STORM WATER REPORT

Cobey Creek
Mixed Use Development
Lee's Summit, MO

1. Original Storm Report-May 22, 2018
2. Addendum 1- July 1, 2019- Effective Height and Energy Dissipation additions to North Pond
3. Addendum 2- August 3, 2020- Updated South Pond Outlet Structure-Pond Pack Print out.
4. Addendum 3- October 8, 2020- Approved Outlet Structure Geometric Changes from Circular to Square and Rectangular

Addendum 3
Cobey Creek
Mixed Use Development
Lee's Summit, MO

SIDE VIEW
FACING WEST SIDE

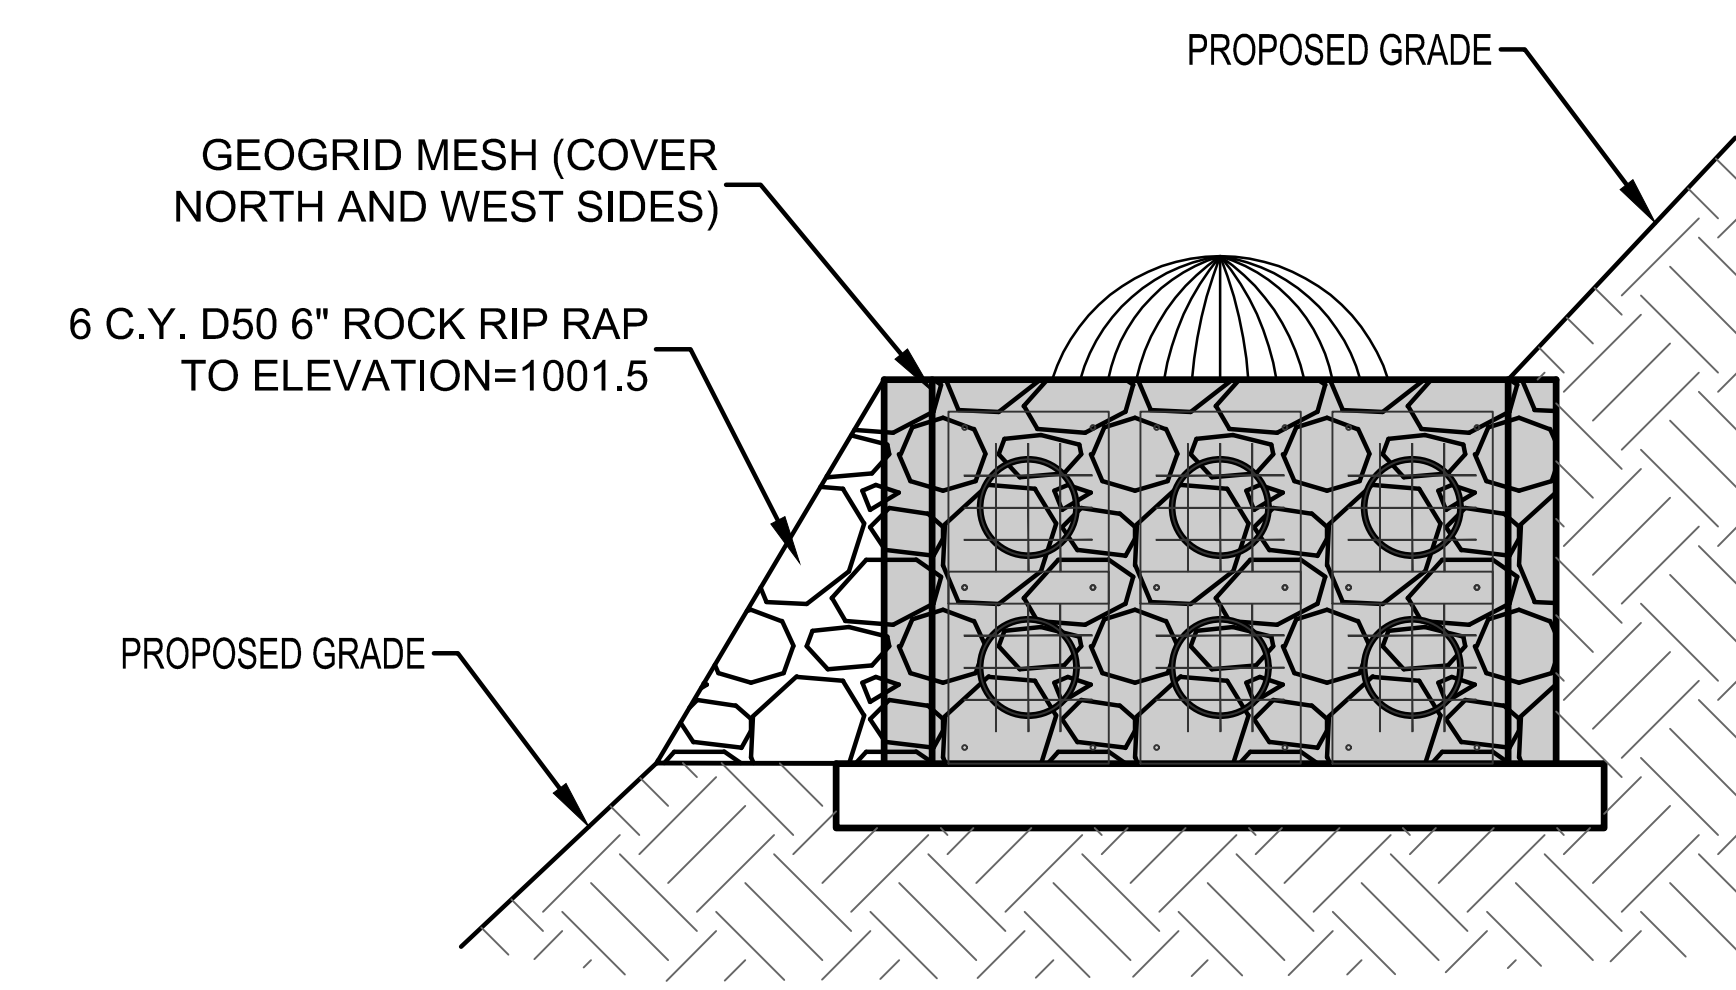
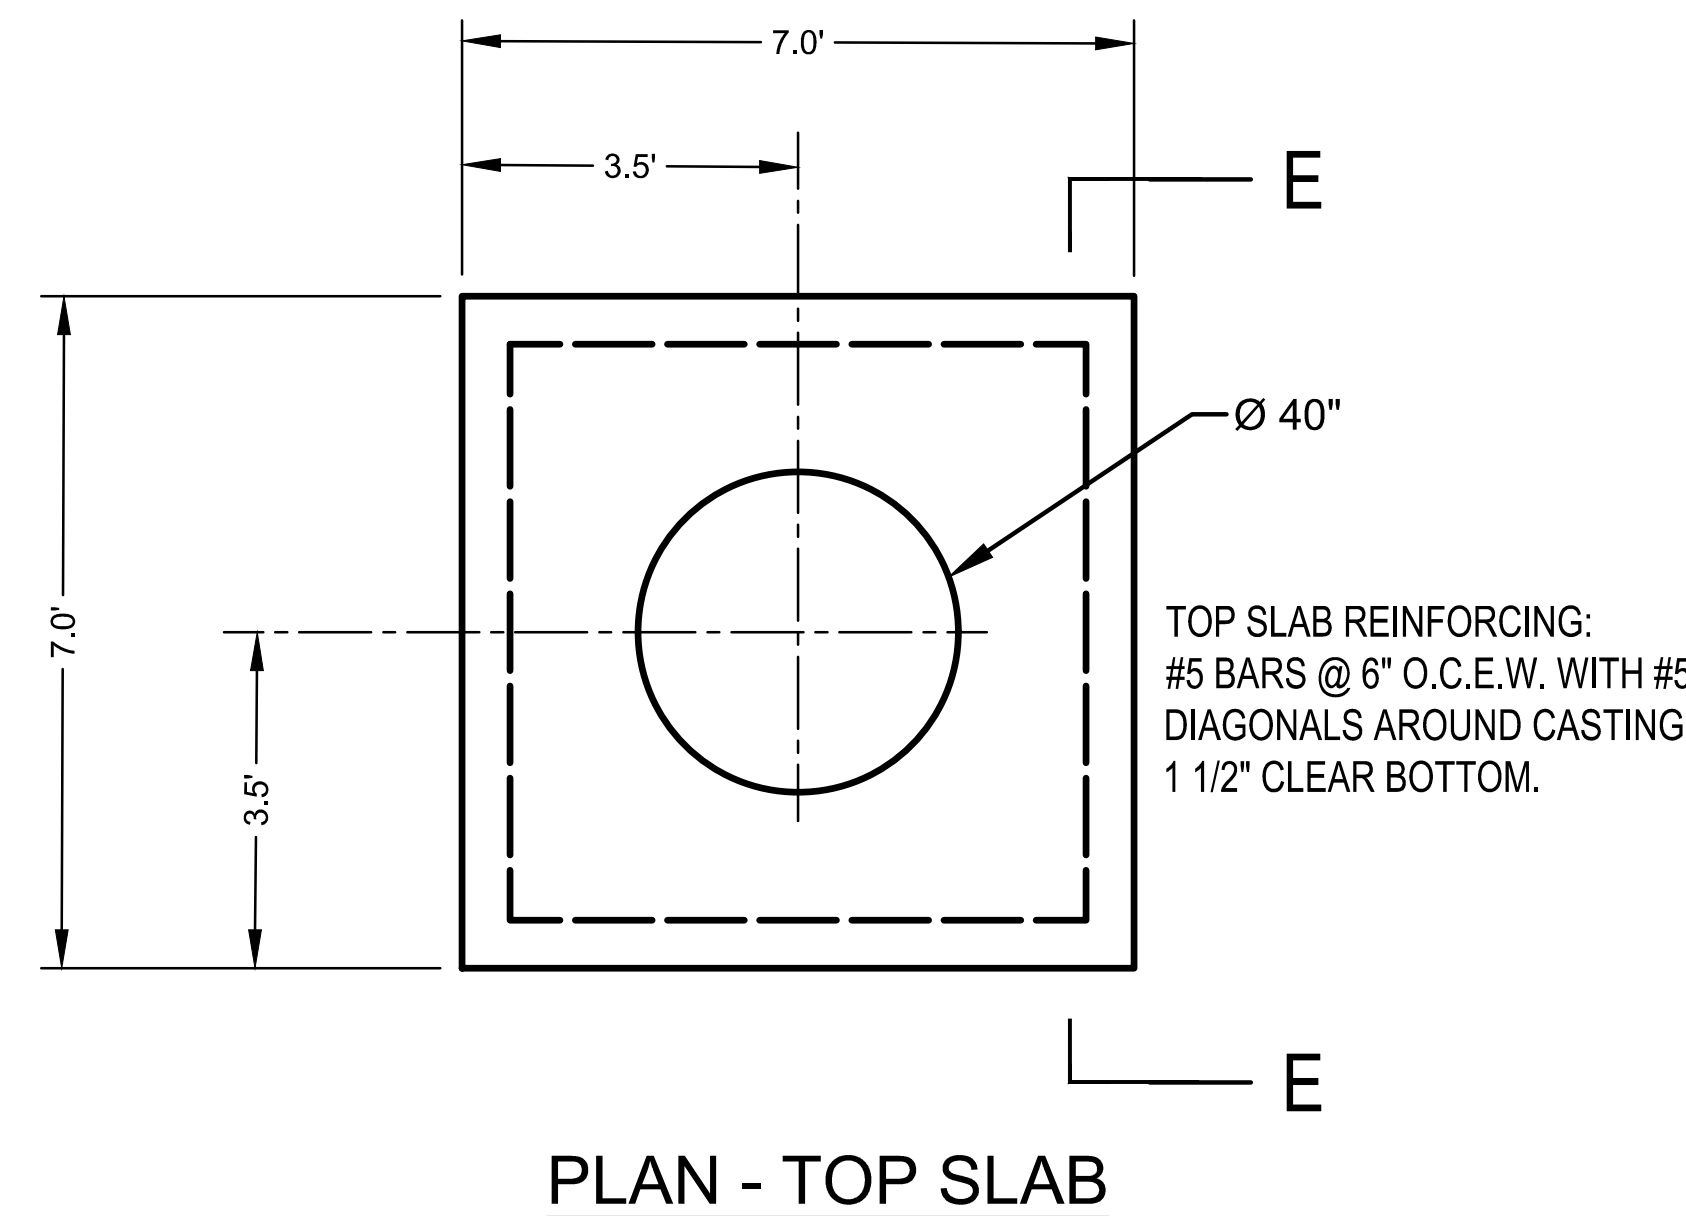
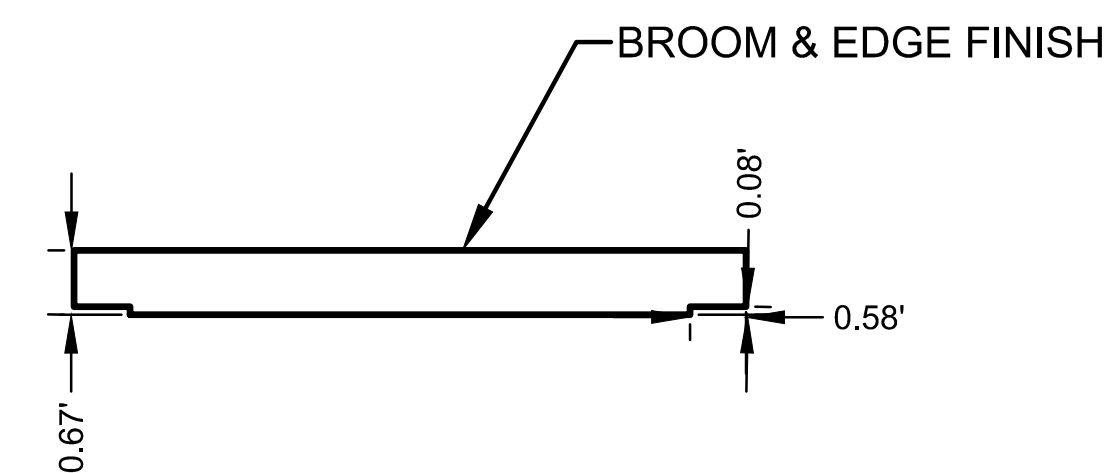
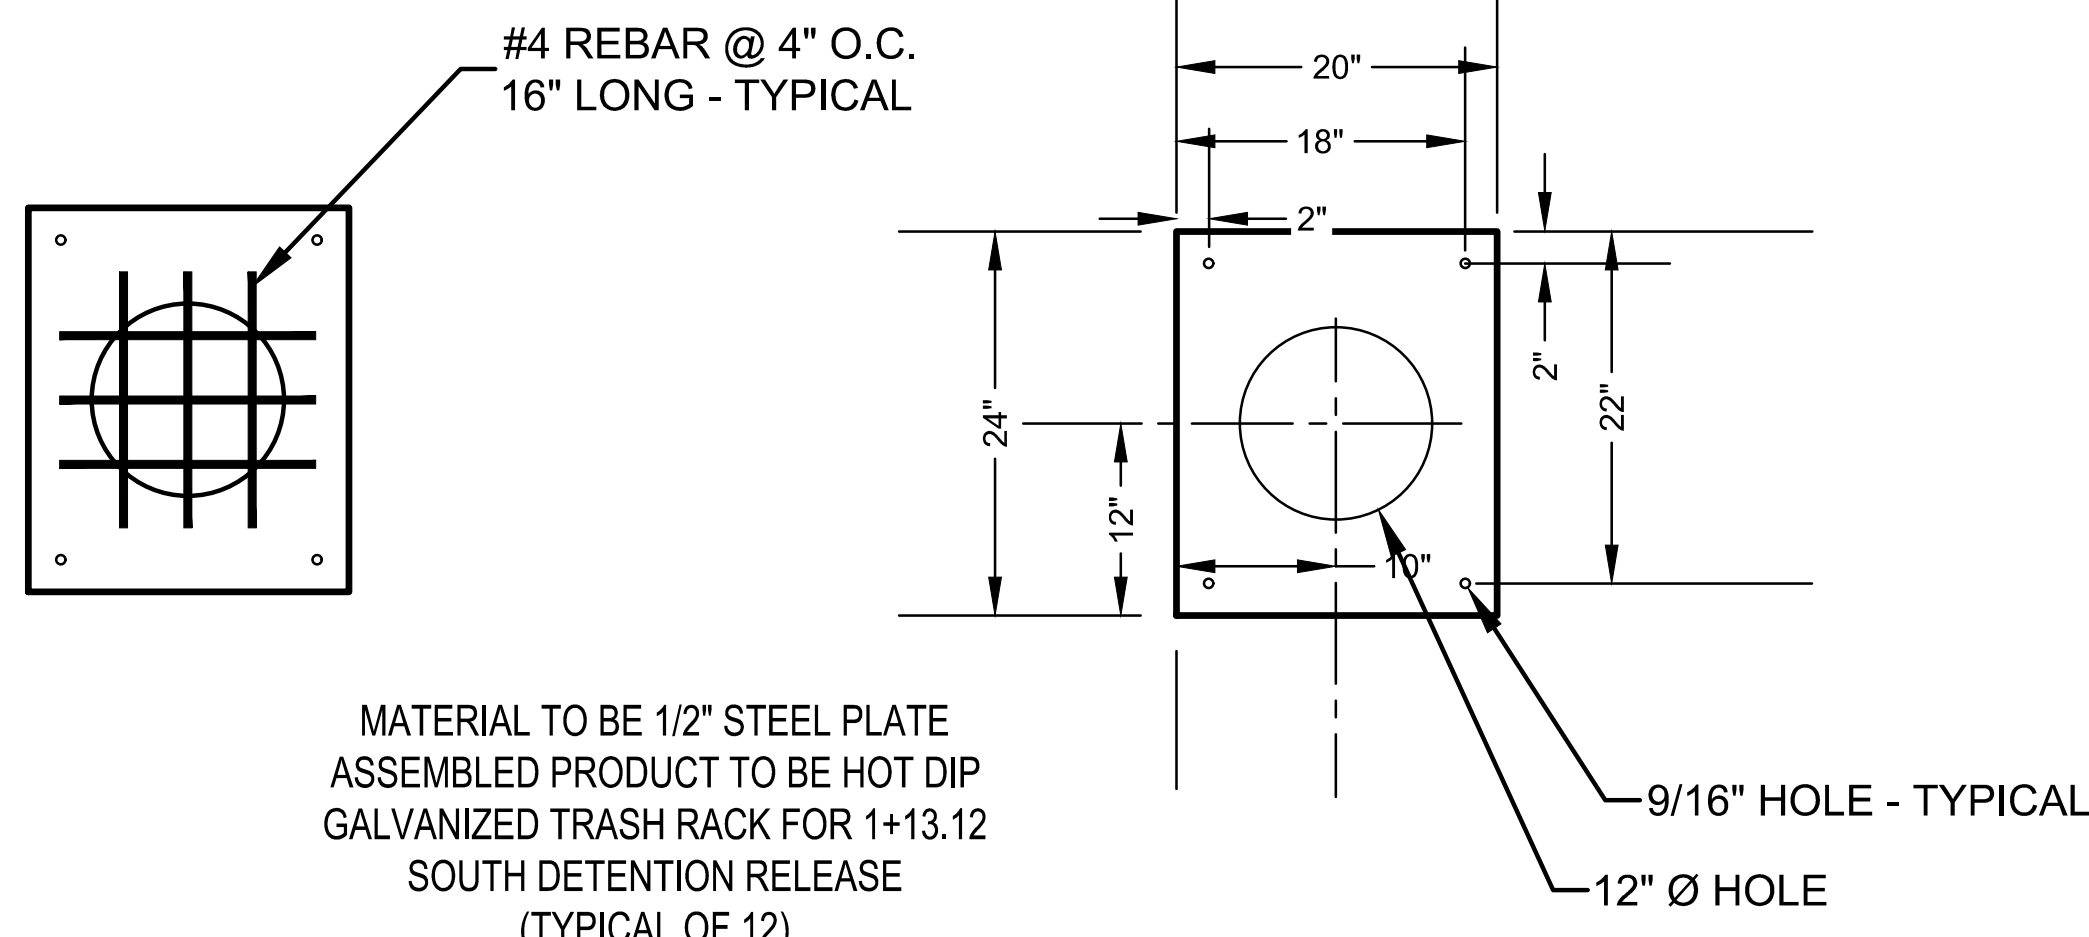
This addendum to the final storm report for Cobey Creek, Phase 1, is prepared to address the updating of the Pond Pack information for the south pond outlet structure. The attached Pondpack print out addresses the flow characteristics associated with six- 12inch diameter holes shown on the new square outlet structure detail, also attached.

The structure was changed to square from a circular manhole due to the unavailability of the manhole in a 6 foot diameter, as designed and approved in the original plans. The Pond pack information is provided as confirmation that original release orifices (12" holes) on the circular manhole when placed on the square version, shows no changes to the hydraulic function of the outlet structure within the pond.
